**TETRA TECH, INC.**  
Cape Fear Building, Suite 105  
3200 Chapel Hill-Nelson Hwy.  
P.O. Box 14409  
Research Triangle Park, NC 27709  
Telephone: (919) 485-8278  
Telefax: (919) 485-8280

## **COMPARISON OF BAHM AND CONTRA COSTA APPROACHES TO HYDROMODIFICATION MANAGEMENT PLAN REQUIREMENTS**

**To:** Janet O'Hara (CA RWQCB 2)

**Date:** December 7, 2007

Figure 8. BAHM Setup Screen for Flow-Through Planter

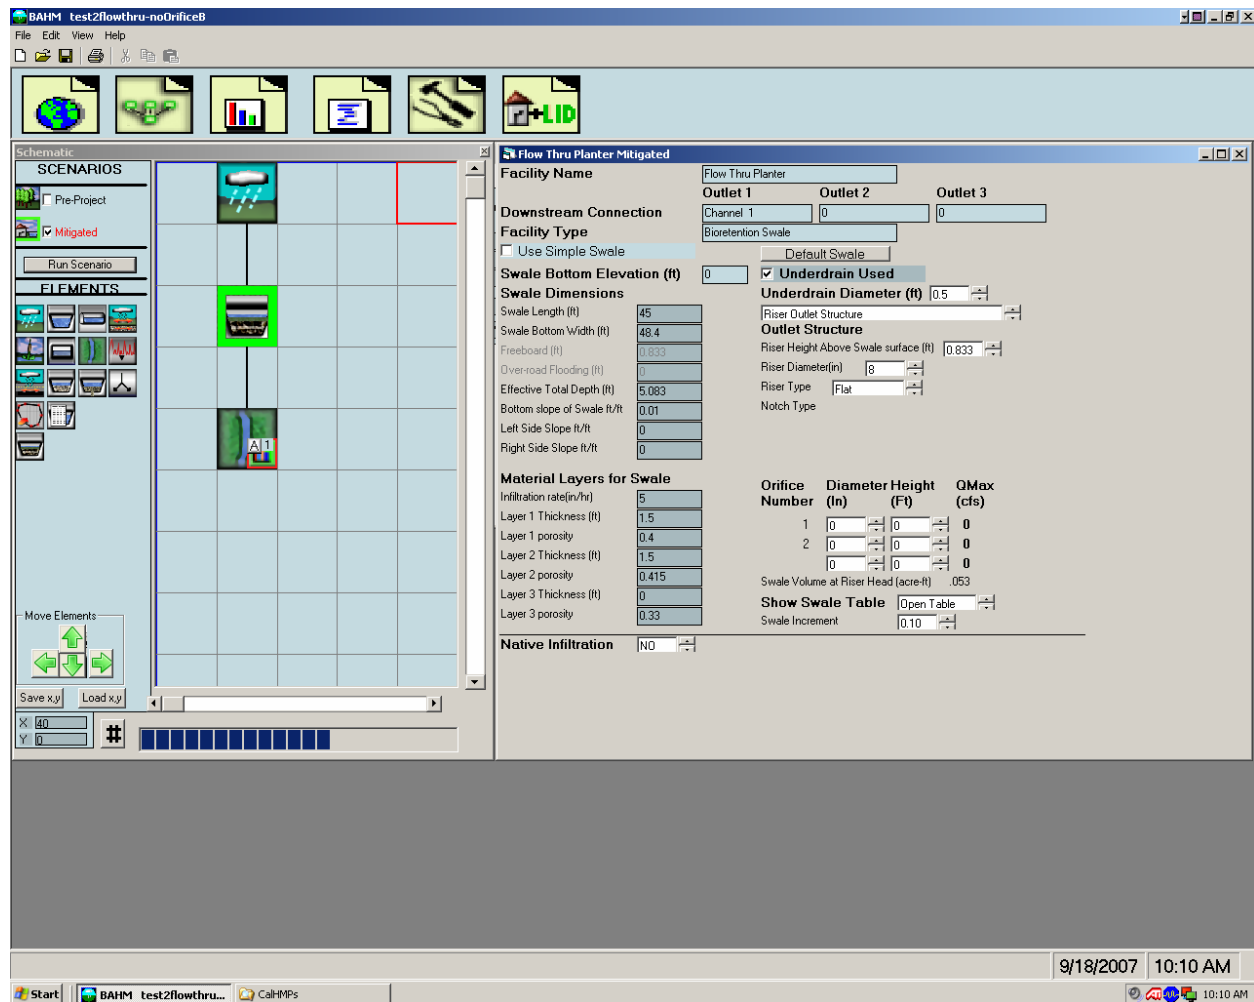
<sup>11</sup> As shown in Figure 8, the BAHM interface includes an option to specify an orifice for the bioretention swale element. It would seem that this should be used to establish flow control on the underdrain. However, when this option is selected, BAHM creates an FTable that includes an orifice entry into the riser in the upper soil layer. The orifice option thus cannot currently be used to control rate of discharge from the underdrain in the lower (gravel) layer. Presumably, BAHM could be used to better match the Contra Costa design by specifying a smaller underdrain pipe diameter (rather than orifice control), thereby limiting the maximum outflow to the desired level. That approach is not, however, discussed or recommended in the BAHM documentation and so was not implemented in the tests described here.

The HSPF UCI file generated by BAHM for this scenario appears to have other errors as well. In both BAHM and the Contra Costa approach, the planter is represented by two connected reach elements (RCHRES), each with a corresponding FTable describing volume-flux relationships. The upper RCHRES represents the amended soil layer (1.5') plus freeboard in the planter above the soil surface and the riser. The lower RCHRES represents the gravel layer (1.5') and underdrain. (The setup used assumes D soils, where an underdrain would be needed and infiltration out of the bottom of the planter would be minimal.) For the upper layer, BAHM generated the FTable shown in Table 3 in Appendix A, in which Outflow 1 represents discharge through the overflow riser and Outflow 2 represents percolation to the lower (gravel) layer, assuming sufficient pore space availability.

Examination of Table 3 shows that BAHM simulates a constant infiltration rate, independent of head or pore suction effects. Overflow through the riser begins at 1.5', which is the depth of the surface layer. It should start at  $1.5 + 0.833 = 2.333'$ .

The lower layer is also specified as 1.5' in thickness. BAHM creates the FTable shown in Table 4 of Appendix A for this layer. The representation of this layer created in the BAHM FTable is just less than 3' in thickness, instead of 1.5', as intended. The total effective depth calculated by BAHM is 5.083' (bottom layer + surface layer + freeboard + over road depth). It will be noted that the sum of the maximum depth in FTable 2 and the next to last depth in FTable 1 is approximately equal to the total effective depth. It would appear that BAHM has allocated the total effective depth incorrectly between the two FTables.

The outflow from the underdrain specified in FTable 2 is also suspect. This begins at a depth between 0.79 and 0.84 feet, which is equal to the height of the riser pipe above the amended soil layer. The outflow rate rises to a maximum at a depth of 2.5', then drops suddenly.

The reason for this confusion arises from the BAHM process of simulating the flow-through planter through modifications of the bioretention swale element. The BAHM description of implementation of the flow-through planter shows the underdrain at the bottom of the gravel layer, and states that "stormwater enters the planter above ground and then infiltrate[s] through the soil and gravel storage layers before exiting through a discharge pipe," as would be expected. However, the information on the basic bioretention/rain garden element provides conflicting assumptions. Specifically, "the bottom of the underdrain pipe is assumed to be at the bottom of the *amended* soil layer." As a result, the interface seems to have set up the model with the underdrain 1.5 ft above the bottom of the planter, and continues FTable 2 through the depth of the gravel and amended soil. However, FTable 1 is not set up to represent only storage above the surface of the amended soil as (1) flow into the riser starts at a depth of 1.5', not 0.833', and (2) infiltration from the upper to the lower layer is only a function of depth in FTable 1. Similar problems appear to affect BAHM simulation of other LID components. For example, a bioretention area is also supposed to be simulated with an underdrain at the bottom of a subsurface gravel layer, but BAHM will place the underdrain at the bottom of the upper, amended soil layer.

These apparent errors in the BAHM interface will have different types of impacts on the flow control simulated by the flow-through planter. First, there is dead storage at the bottom of the lower layer. As evapotranspiration is applied to this layer, some flow that should exit through the underdrain will be converted to evapotranspiration. Second, the height of the riser inlet above the bottom of the underdrain, as represented in the FTable, is 3.667' (given that the underdrain is represented as 0.833' above the bottom of the lower layer), rather than the intended 3.833'. This would result in overestimation of bypass

1. BAHM simulation of IMPs should be improved. There appear to be errors in the way BAHM sets up the flow-through planter representation, as noted above. In addition, the representation of infiltration is simplistic and should be refined.

**Figure 9. Flow Duration Curve for BAHM Implementation of Flow-Through Planter, with and without ET Applied to Lower Layer**

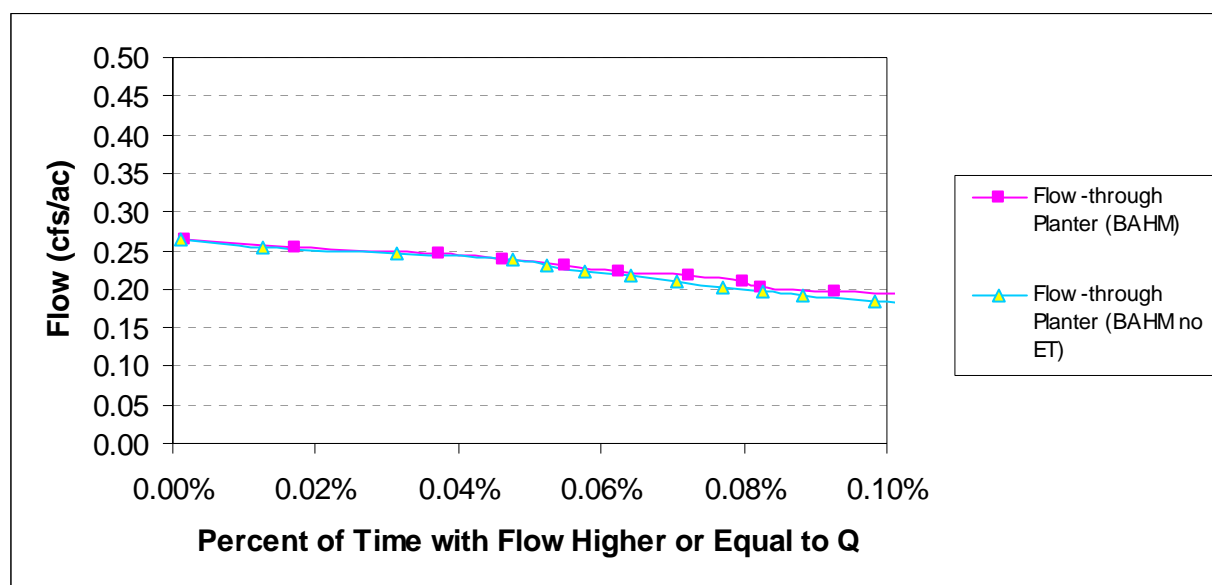
Prior to cross-comparison of BAHM and the Contra Costa approach to the flow-through planter, the effect of assigning ET to the lower soil layer in BAHM was investigated. Over the period of the simulation, removing ET from this layer results in an increase in total flow through the underdrain of only 0.70 percent. The impact on the flow duration curve is minimal, as shown in Figure 9.

Experiments with different size IMPs in BAHM revealed conditions in which, at the highest (least frequent) flows, there is a greater frequency of exceedance predicted when the simulation is done with ET on the lower layer than when it is done without ET on the lower layer. This seems counterintuitive, but does have an explanation. The divergence only occurs when the total flow is greater than the maximum infiltration rate of 0.202 cfs/ac. When ET is assigned to the lower layer, there is typically more empty pore space available in the lower layer prior to a runoff event, which in turn can result in smaller volume stored in the surface layer, which in turn results in less infiltration at the start of a runoff event when the antecedent volume is below the first step in the surface FTable. On the other hand, the antecedent volume stored in the lower layer tends to equalize between the simulations with and without ET as soon as infiltration begins. BAHM is set up so that outflow demand is estimated with a KS weighting factor of 0.5 (the HSPF default). This parameter weights the outflow between the outflow demand present at the beginning of the time step and that present at the end of the time step. Therefore, the higher infiltration rates simulated when ET is applied to the lower layer result in a greater calculation of outflow demand at the end of the time step because the total head (antecedent volume plus infiltration) is greater. This

problem could be fixed by setting the KS factor to zero (so that outflow demand is dependent only on the volume at the start of the time step) or by using a shorter time step.

It was also noted that the BAHM simulation without ET produces many more days with small but non-zero discharges (13.5 percent) than does the simulation with ET on the lower layer (9.0 percent). This is an anomaly due to the way in which BAHM constructed the FTable, which (incorrectly) places the underdrain 1.5' above the bottom of the planter. When ET is applied to the lower layer, water declines below the underdrain; with no ET it remains filled to just below the underdrain and thus responds to small amounts of infiltration.

**Figure 10. Simulation of Flow-Through Planter by BAHM and Contra Costa Models (Daily Results)**

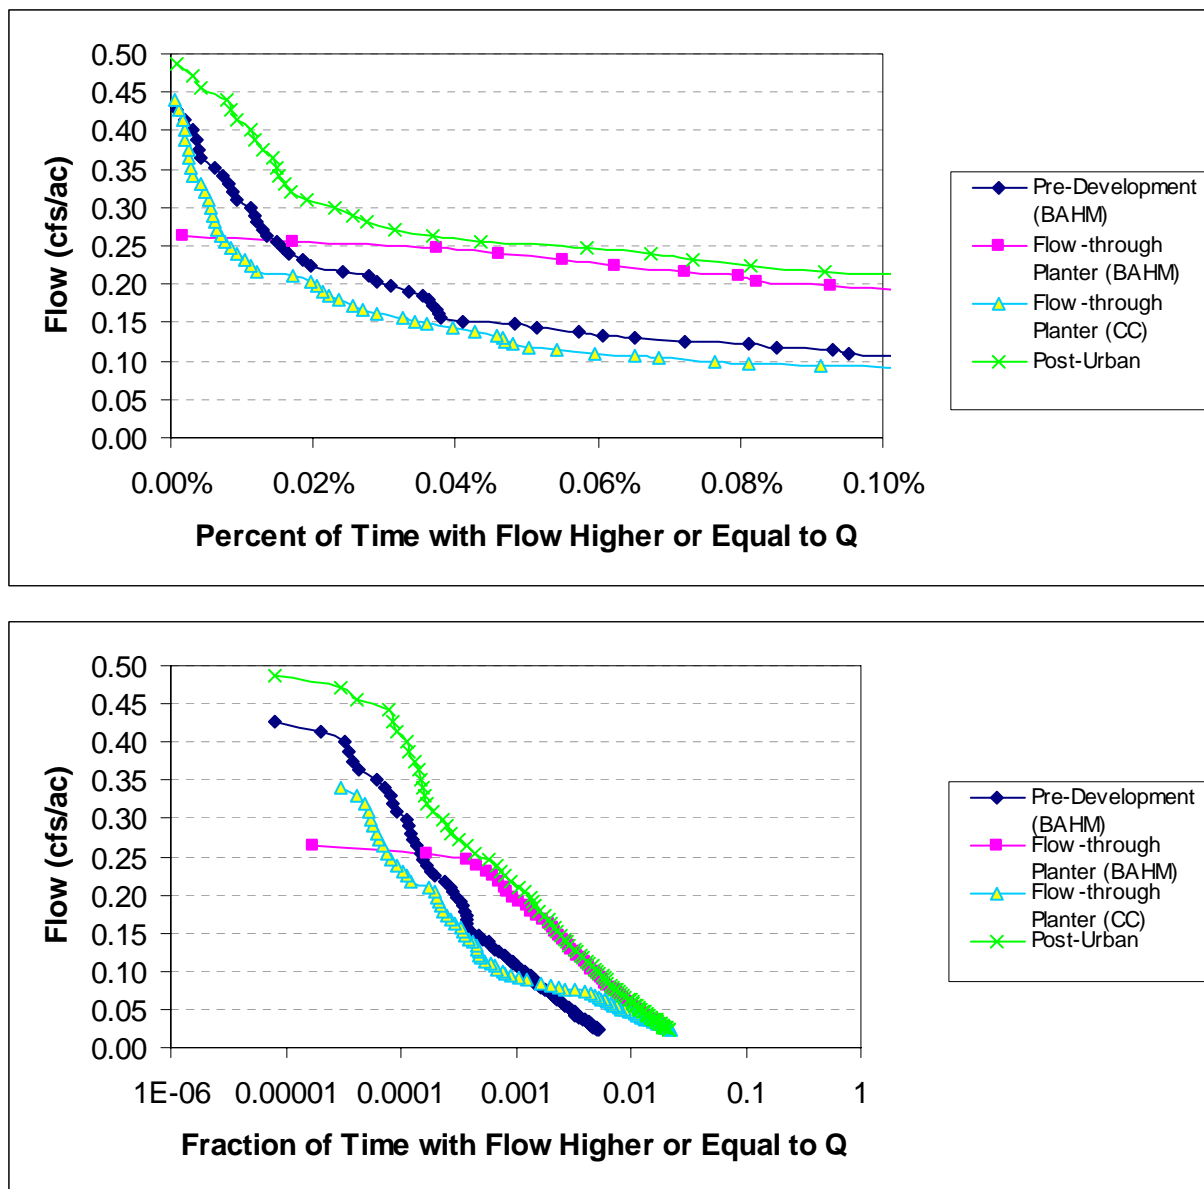
Figure 10 compares the simulation of the flow-through planter by both the BAHM and Contra Costa approaches with the flow-durations from the pre-development condition (scrub/shrub) and the unmitigated post-development condition (100 percent impervious). The same results are shown in two ways – on both arithmetic and logarithmic scales.

The figure first shows the large difference between flow durations for pre-development and unmitigated post-development conditions. Both the BAHM and Contra Costa models remain below the pre-development flow duration curve for higher flows – specifically those that exceed the infiltration rate, equivalent to 0.25 cfs/ac on the flow-through planter with sizing factor of 0.05. Below this level, the BAHM planter achieves little control and quickly converges to the unmitigated post-development line. This occurs primarily because BAHM does not provide outlet control on the underdrain – thus flows less than 0.25 cfs/ac that infiltrate to the lower layer are discharged essentially unmodified. (As discussed in Section 1, BAHM is designed to account for the presence of IMPs, but does not attempt to achieve matching of the flow-duration curve through IMPs alone.)

The Contra Costa simulation of the planter is intended to provide flow duration matching down to the 0.5Q2 level. For this site, the long-term 0.5Q2 is 0.117 cfs/ac (flows were lower during the 1979-1987 period shown on the graphs). The Contra Costa simulation actually remains below the pre-development flow duration curve down to about 0.088 cfs/ac, but is above this curve in the lower region above the 0.1Q2 flow of 0.0234 cfs/ac. Control below 0.5Q2 is (unintentionally) achieved primarily because the Contra Costa modeling underestimates pre-development flows, as discussed in Section 2. The lack of full mitigation for flows near 0.1Q2 is consistent with Contra Costa's stated intentions, and Figure 14 in the HMP shows that the flow-through planter is not capable of achieving a match to the flow duration curve down to the 0.1Q2 level. (Note that some of the other types of IMPs simulated by Contra Costa do achieve control to 0.1Q2).

3. Some IMPs simulated by Contra Costa do not achieve matching of flow-duration curves down to the 0.1Q2 level, and thus these IMPs do not meet current Permit requirements for hydromodification control.
